NEPAL ELECTRICITY AUTHORITY
Transmission Directorate
Tamakoshi-Kathmandu 220/400 kV Transmission Line Project

IFB No. : ICB-TD-TKTLP-073/74-02: Procurement of Plant for Gas Insulated 220 kV Barhabise Substation (Design, Supply, Install and Commission)

Clarification 1: Response to the Pre-Bid Queries

Sheet No.
 BK-TL
 SS-1

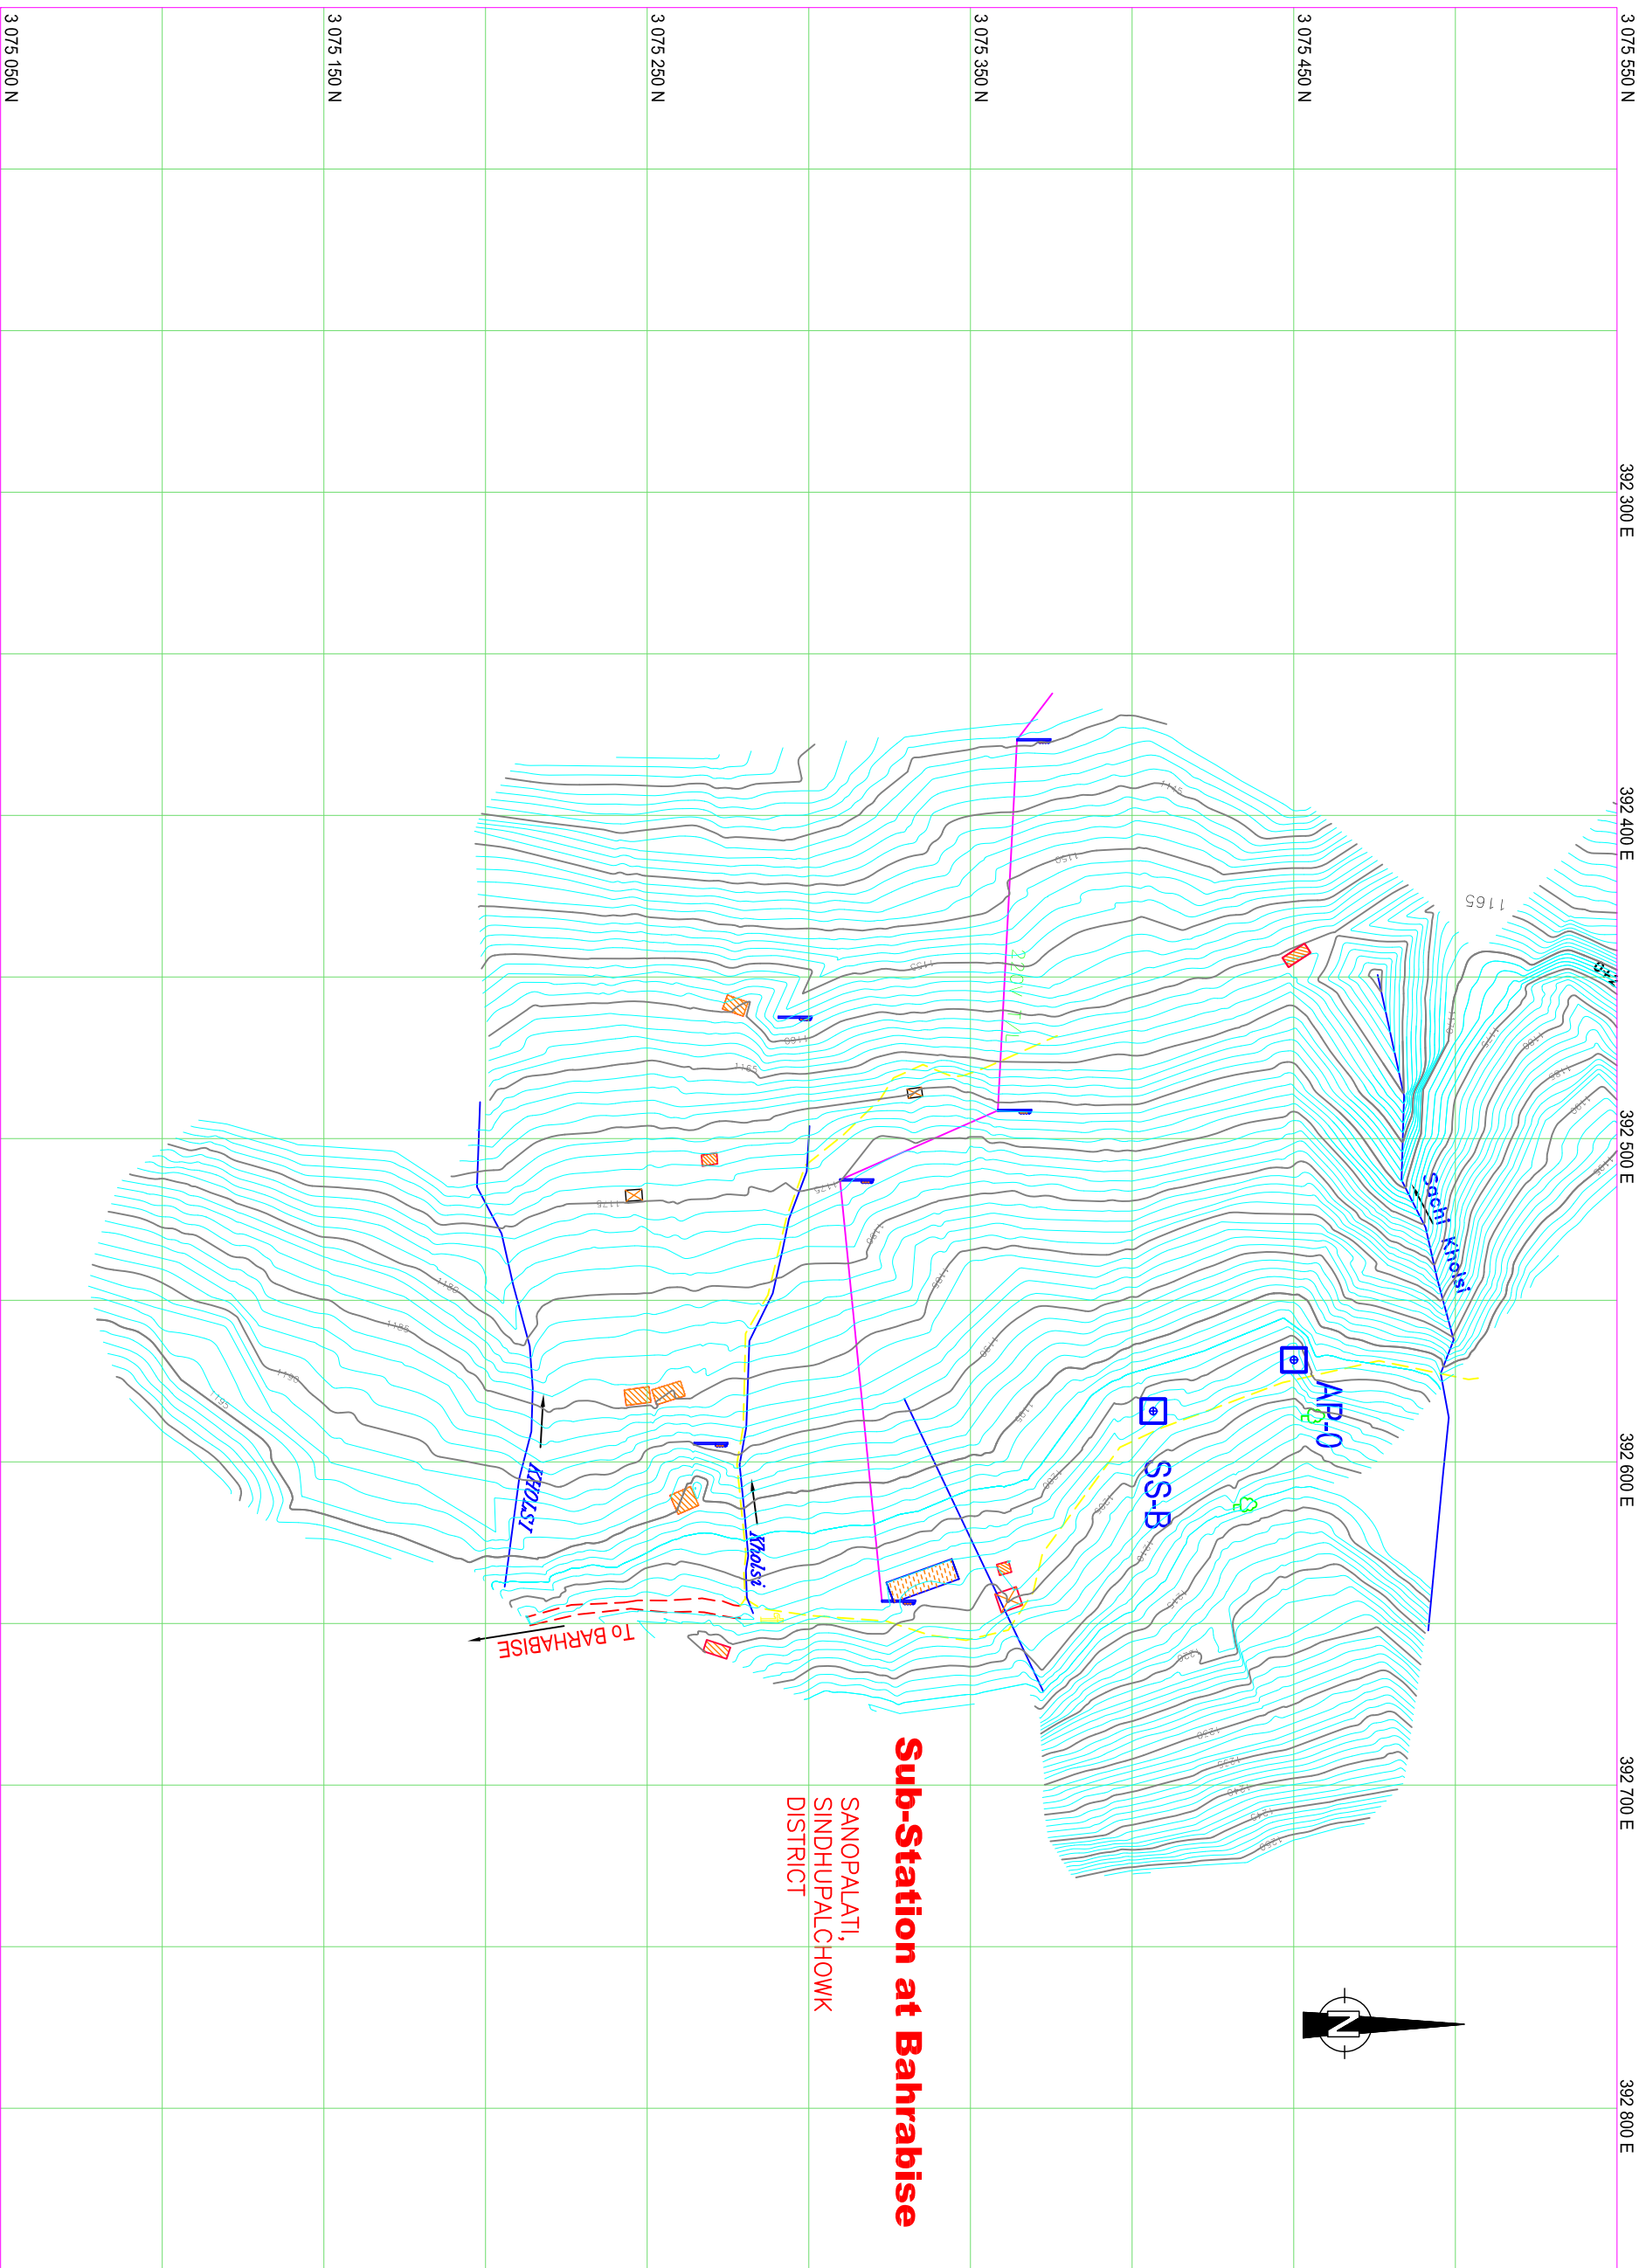
46		On-site survey, the road to the location of BAHHRABISE substation is narrow and rough, the slope is larger, the turning radius is smaller, please clear whether the road to meet the power transformer transport requirements.	Bidder has to visit site and acquaint themselves for obtaining information related to Road.
47		Please make sure that all pages of the tender documents are signed and stamped and submitted.	It is usual practice to sign and stamp all the pages and submit with the Bid.
48	Volume II (A) , Section 1, Clause 4.1 (z) and 13 (v)	Please clarify whether the upgrading of approach road is in the scope of Contractor?	Please refer Clause 4.1 (z) and Clause 13 (v) of Section 1, PSR of Volume II (A) and Schedule 4(a), Item I, Part C, No. 29 of Vol-III regarding the scope of contractor and owner.
